**DECISION NOTICE FOR OPERATIONAL WORKS
OCEAN BREEZE STAGE 5B – (19 LOT SUBIVISION) -
LOT 901 ON SP264287 – BARRABAL DRIVE, COOYA BEACH**

**DECISION NOTICE FOR OPERATIONAL WORKS
OCEAN BREEZE STAGE 5B
COOYA BEACH ROAD, BONNIE DOON**

Operational Works (Engineering) excluding Landscape and Lighting Works

APPENDIX A: APPROVED DRAWINGS

Typical Cross Section of Pavement - Street Edge
 BARRABA DRIVE & ROAD J
 DATE: 11/20

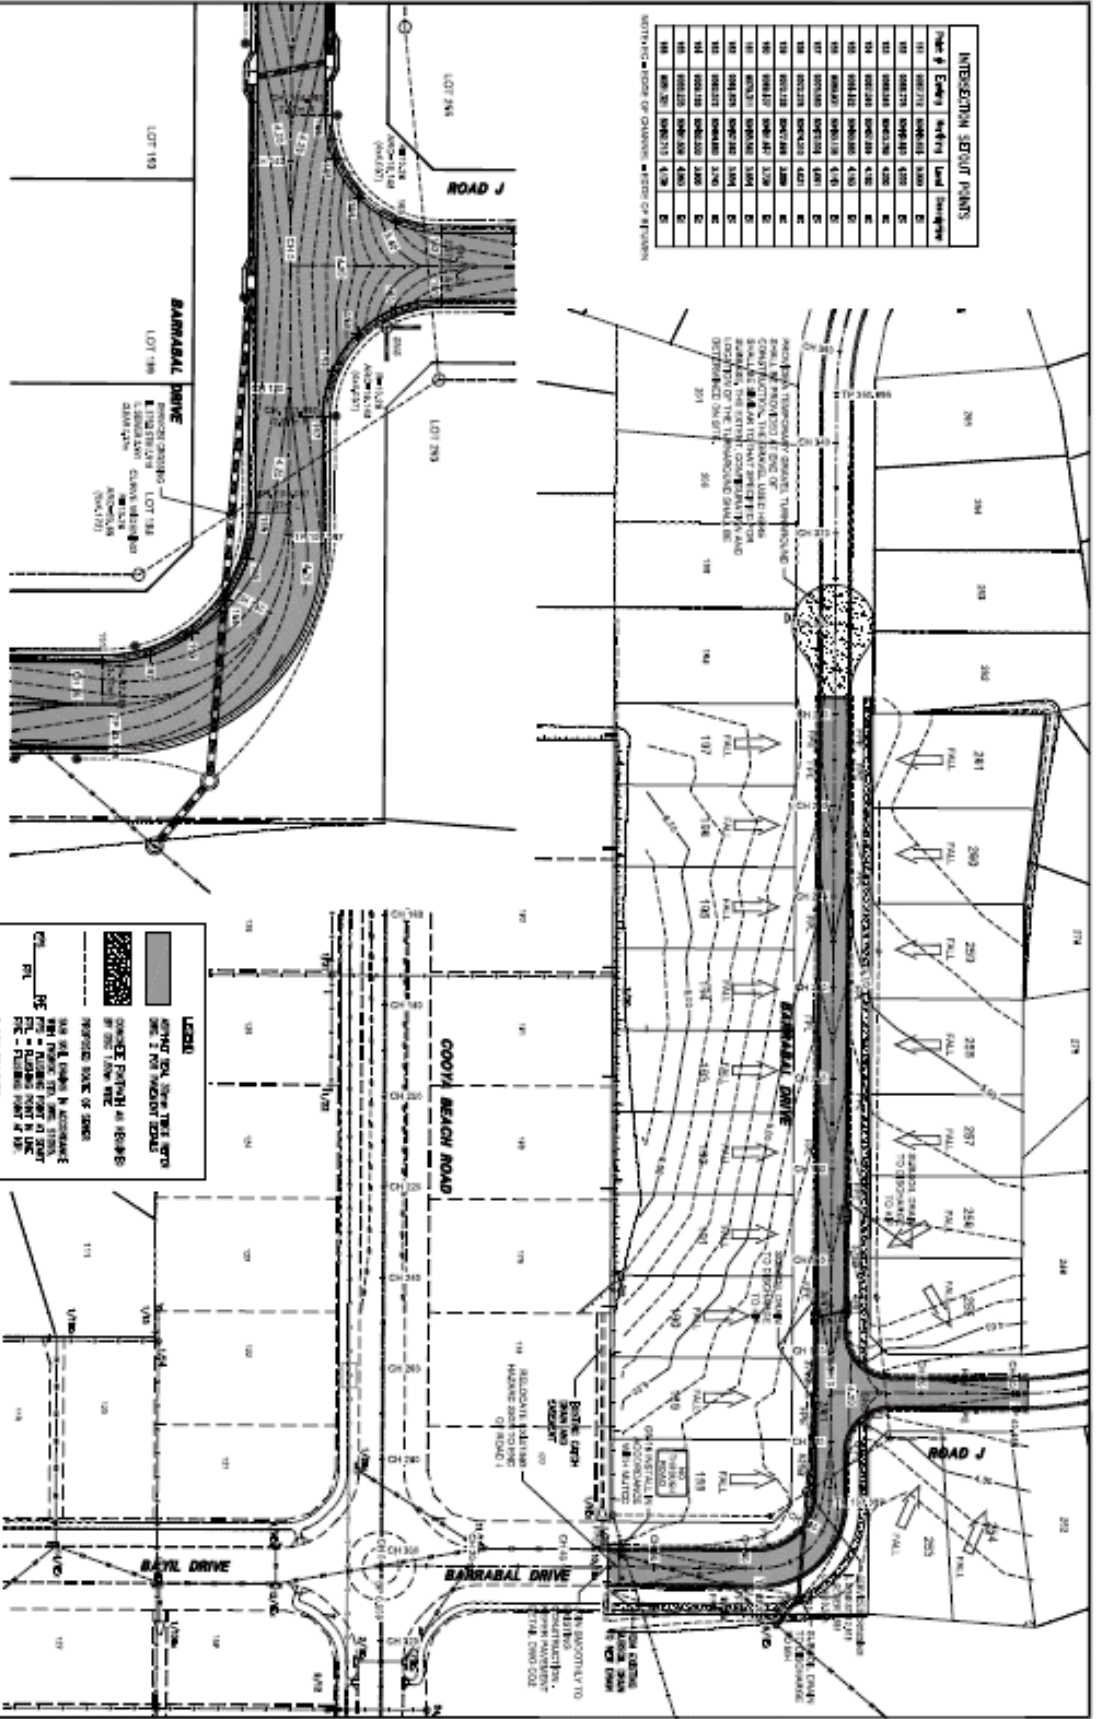
- h. The proposed 2.0m concrete footpath to be installed along Barrabal Drive is to be shown on drawing 1301-C04-Rev (A) - Typical Cross Section Detail. For consistence with previous infrastructure 1.5m concrete footpath to be extended to the intersection of Barrabal Drive and Road J.
